SUBJECT: Correcting Frequency Difference Between

**DATE** 3-19-79

RM-76 and TR-7600/TR-7625

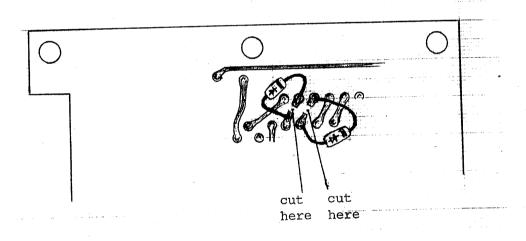
The RM-76 will be about 500Hz higher in frequency than the TR-7600/TR-7625. This will not present any problem most of the time. Our specified tolerance is ±750Hz. The operating frequency may be out of the receiver input of a repeater if the transceiver is turned slightly high, however. The frequency difference may be corrected by adding additional diodes in series with both the 02 and 52 lines in the RM-76. This is shown in the figure below.

The foil paths from the connector to diodes D18 and D19 are cut and the new diodes soldered on the foil side of the board. The cathode end of the diodes is soldered to the connector side. We recommend using either 1S2076 or 1S1555 diodes.
